# Access Compliance Report

## Public Rights-of-Way

### (Curb Ramps)

Intersection ID: 11266	Main Street: AXAR_RD	Cross Street: MULBERRY_CHURCH_RD	Location: NW
ADA ID: 0C1D4E3C549E	Ramp Type: Perp	Initial Pass/Fail: Fail	Overall Compliance: No
Severity Score: 30			
Codes/Mitigation Info/Possible Solution		Field Measurements/Component Compliance

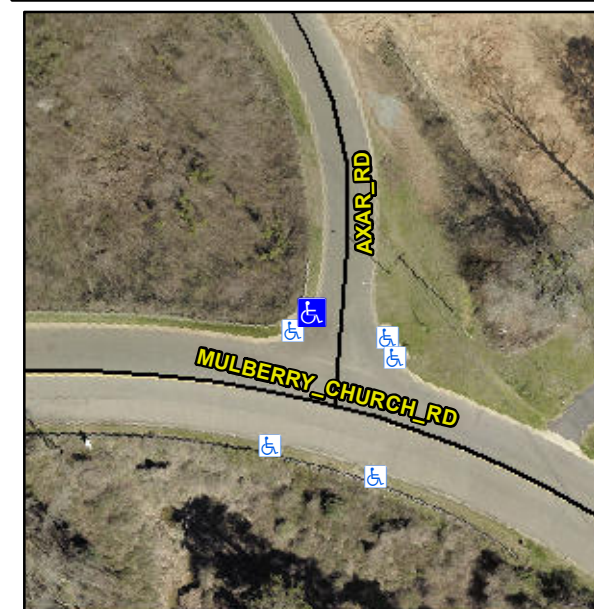
**Not Found, R304.5.1, R304.2.2**

Compliance	Description	Data	Compliance	Description	Data
N/A	Ramp Length (in)	66.0	No	Ramp Slope (%)	9.6
No	Ramp Width (in)	35.0	Yes	Ramp XSlope (%)	1.3
N/A	Flare Type LT	N/A	N/A	Flare Type RT	N/A
N/A	Flare Slope LT (%)	N/A	N/A	Flare Slope RT (%)	N/A
N/A	Flare Traversable LT?	N/A	N/A	Flare Traversable RT?	N/A
N/A	Landing Length (in)	N/A	N/A	DWS Provided?	N/A
N/A	Landing Width (in)	N/A	N/A	DWS Contrast?	N/A
N/A	Landing Slope (%)	N/A	N/A	DWS Length (in)	N/A
N/A	Landing X Slope (%)	N/A	N/A	DWS Full Width?	N/A
N/A	Landing Curb? (Y/N)	N/A	N/A	DWS Offset (in)	N/A
N/A	Shared Landing?	N/A			
N/A	Gutter Ponding?	N/A	N/A	Gutter Slope (%)	N/A
N/A	Gutter Lip Ht (in)	N/A	N/A	Gutter X Slope (%)	N/A
N/A	Painted X Walk1?	No	N/A	Painted X Walk2?	N/A
	X Walk 1 Direction	To E		X Walk 2 Direction	N/A
N/A	X Walk 1 Width (in)	N/A	N/A	X Walk 2 Width (in)	N/A
	X Walk 1 Slope (%)	1.1		X Walk 2 Slope (%)	N/A
	X Walk 1 X Slope (%)	1.8		X Walk 2 X Slope (%)	N/A

**Remove & Replace Entire Ramp.**
